Historic Architectural Review Commission
Staff Report for Item 4

Application Number: H17-03-0011

Address: #1000 Southard Street

New accessory structure and new rear IPE deck.

A-1

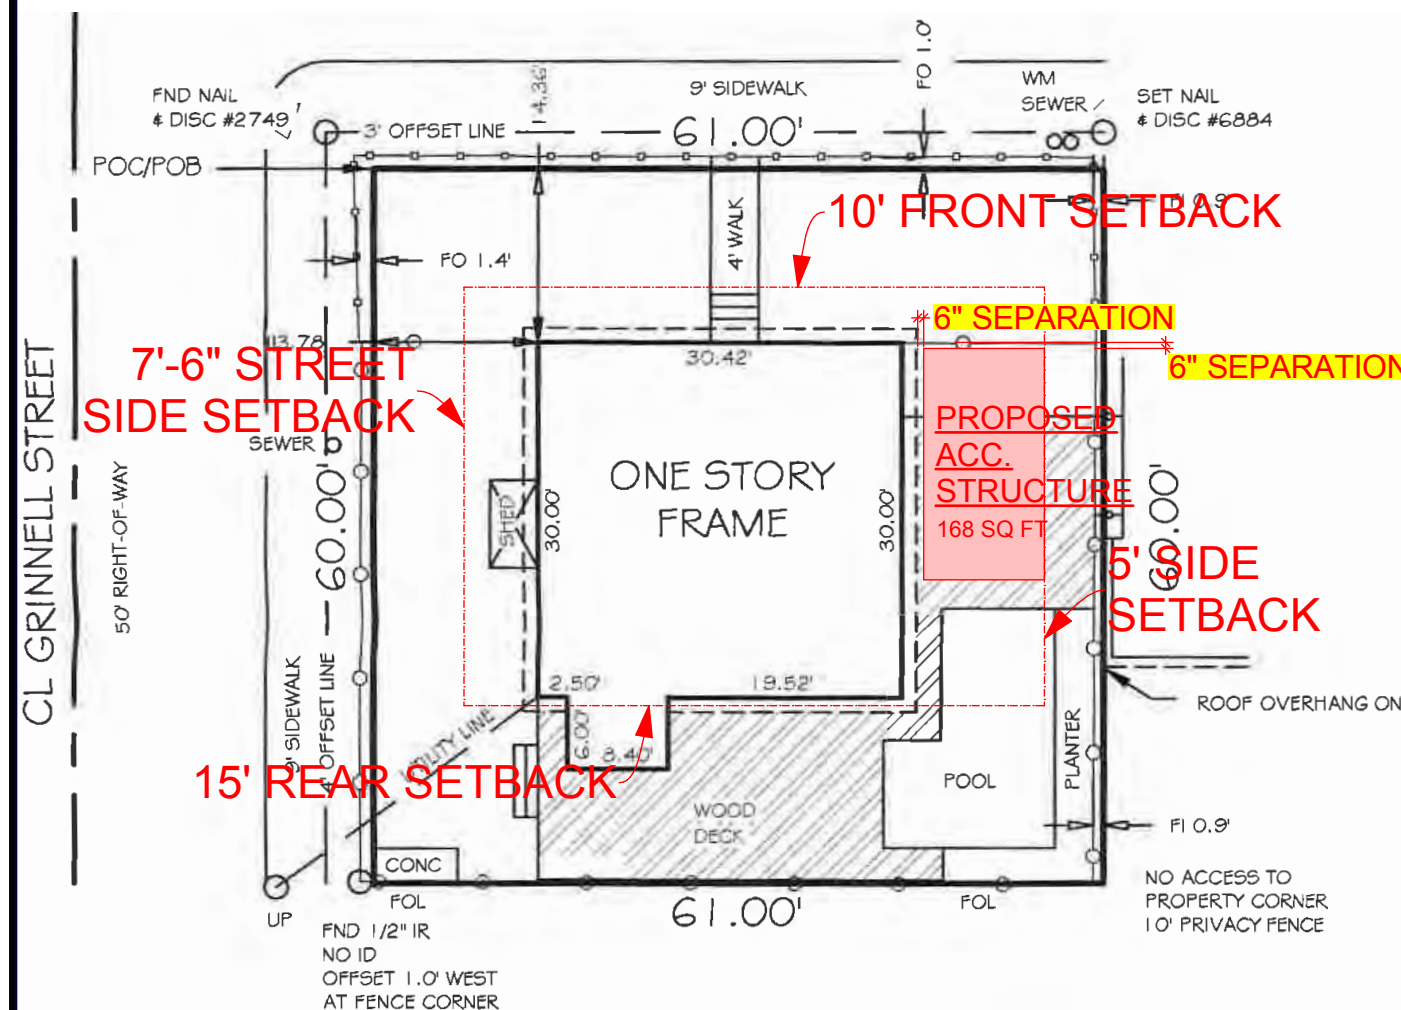
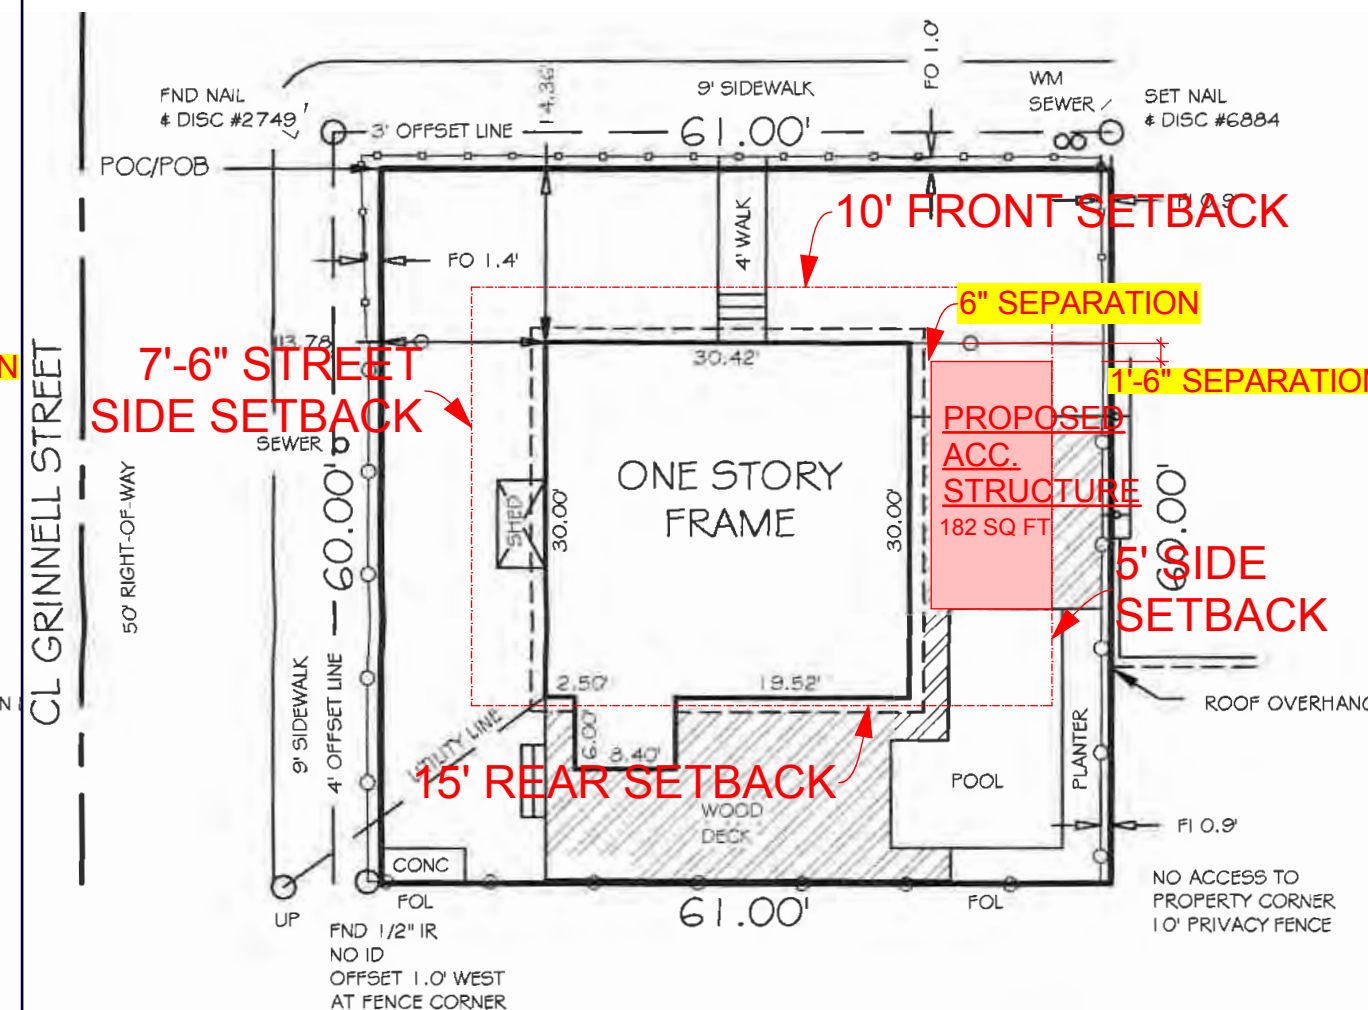
It is staff’s opinion that the proposed new accessory structure is inconsistent with the cited SOIS and guidelines and HARC guidelines. The proposed scale and proportions as well as the location of the structure are inappropriate, as it will be located close to the main façade of the house and visible from the street. By walking the street, you can find no accessory structures located immediately next to a main house nor visible from the street.
